Access Compliance Report

Public Rights-of-Way

(Curb Ramps)

Intersection ID: 50635	Main Street: RED_WATER_RD	Cross Street: BLUE_BLOSSOM_RD	Location: SE
ADA ID: 66D611E68FC8	Ramp Type: Perp	Initial Pass/Fail: Fail	Overall Compliance: No
Severity Score: 35			
Codes/Mitigation Info/Possible Solution		Field Measurements/Component Compliance

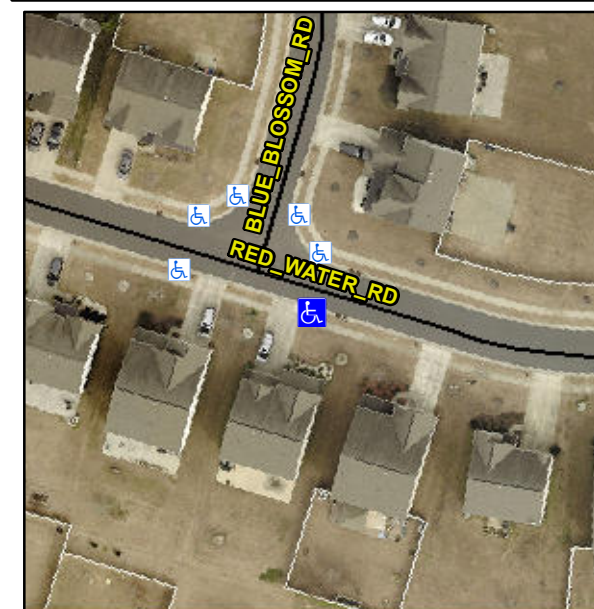
Not Found, R304.5.1, R304.2.2, R304.5.3

Compliance	Description	Data	Compliance	Description	Data
N/A	Ramp Length (in)	47.0	No	Ramp Slope (%)	14.2
No	Ramp Width (in)	47.0	No	Ramp XSlope (%)	3.0
N/A	Flare Type LT	N/A	N/A	Flare Type RT	N/A
N/A	Flare Slope LT (%)	N/A	N/A	Flare Slope RT (%)	N/A
N/A	Flare Traversable LT?	N/A	N/A	Flare Traversable RT?	N/A
N/A	Landing Length (in)	N/A	N/A	DWS Provided?	N/A
N/A	Landing Width (in)	N/A	N/A	DWS Contrast?	N/A
N/A	Landing Slope (%)	N/A	N/A	DWS Length (in)	N/A
N/A	Landing X Slope (%)	N/A	N/A	DWS Full Width?	N/A
N/A	Landing Curb? (Y/N)	N/A	N/A	DWS Offset (in)	N/A
N/A	Shared Landing?	N/A			
N/A	Gutter Ponding?	N/A	N/A	Gutter Slope (%)	N/A
N/A	Gutter Lip Ht (in)	N/A	N/A	Gutter X Slope (%)	N/A
N/A	Painted X Walk1?	No	N/A	Painted X Walk2?	N/A
	X Walk 1 Direction	To NE		X Walk 2 Direction	N/A
N/A	X Walk 1 Width (in)	N/A	N/A	X Walk 2 Width (in)	N/A
	X Walk 1 Slope (%)	1.9		X Walk 2 Slope (%)	N/A
	X Walk 1 X Slope (%)	2.2		X Walk 2 X Slope (%)	N/A

Remove & Replace Entire Ramp.
